Tennessee Valley Authority
Regulatory Submittal for Kingston Fossil Plant

Documents submitted:
Central Area Re-contouring Work Plan, Revision 4

Central Area Re-contouring Work Plan, Revision 4

JACOBS
 KINGSTON FOSSEL PLANT
 TENNESSEE VALLEY AUTHORITY
 CENTRAL DREDGE CELL
 ASH STORAGE CELL
 PHASE 2
 SHEET NO. 51-C-03A

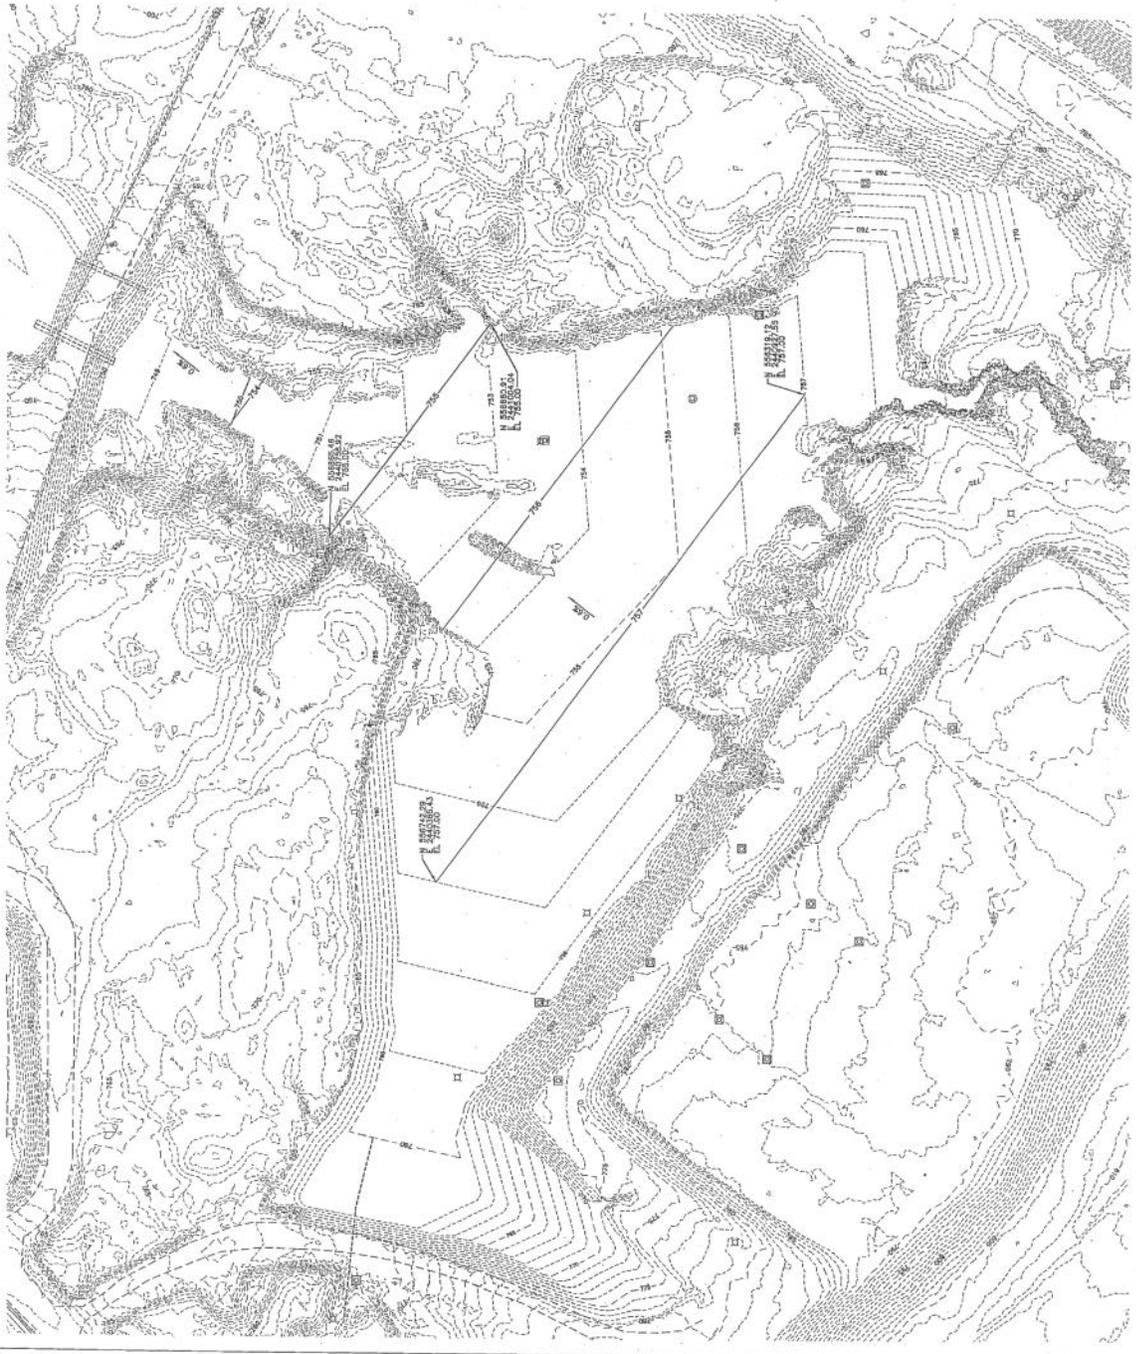
Stantec compared the attached work plan with the current version of our DRAFT subgrade design and it appears that the proposed grading is generally below target working platform elevations. It is noted that the FINAL subgrade design will likely require some degree of cut across proposed fill areas to achieve the desired template. It is recommended that TVA safety professionals evaluate both working conditions at the site and the proposed construction methodology in order to develop appropriate protocols to meet stated objectives outlined in Section 6 of the work plan.
